October 22, 1984  
LD-84-061

Subject: CESSAR Consistency Review Changes

## CESSAR CONSISTENCY CHANGES

NEW FIGURE

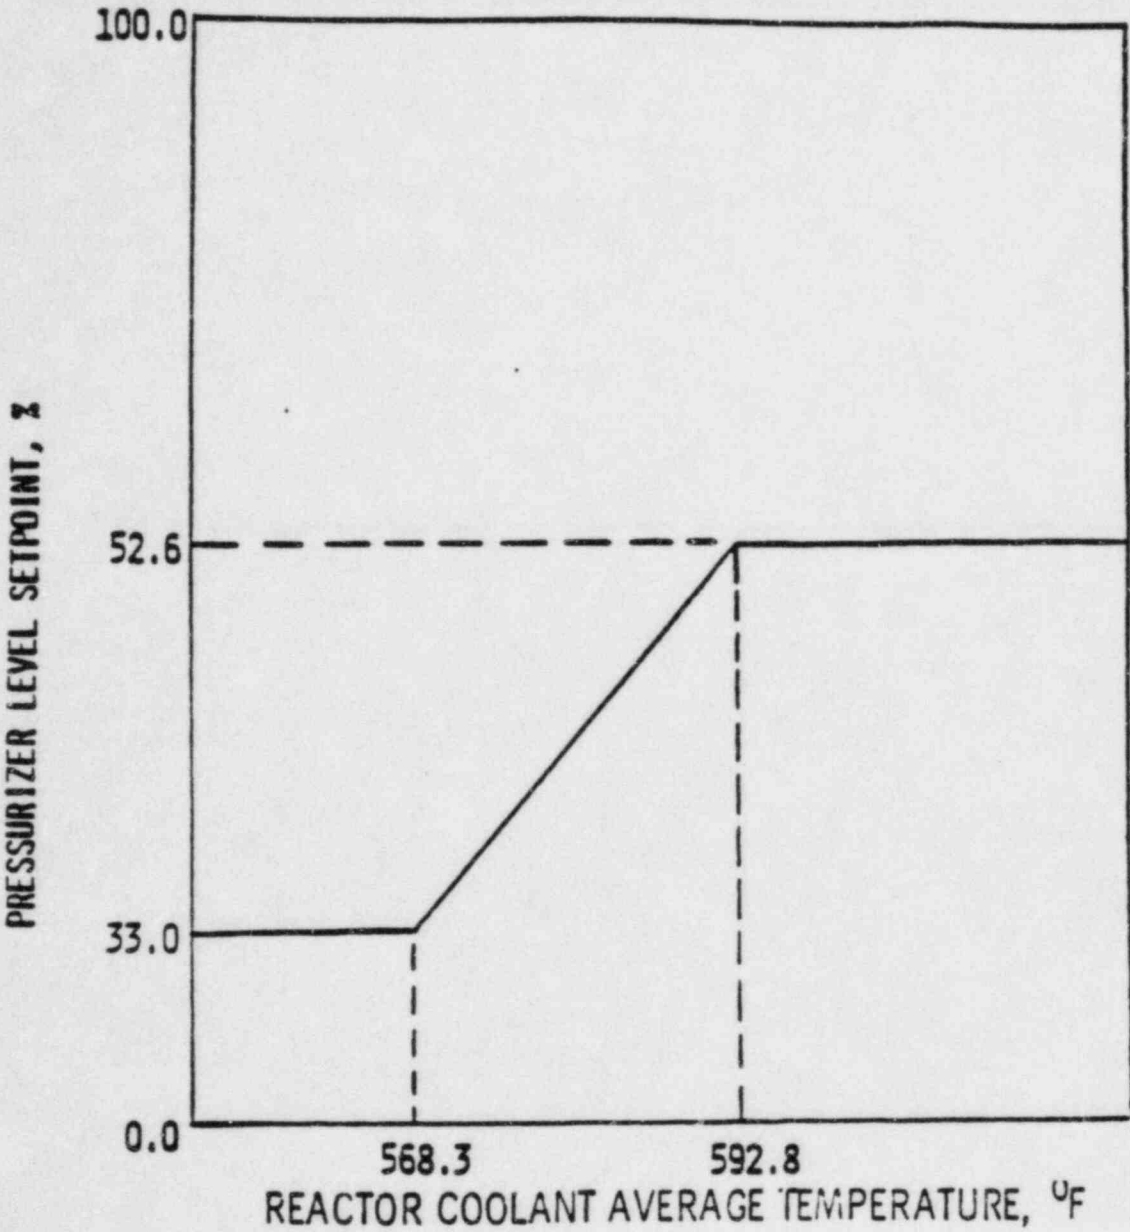
Figure 5.4.10-2 is changed to reflect the actual installed level program. The new figure is consistent with and bounded by the CESSAR safety analysis.
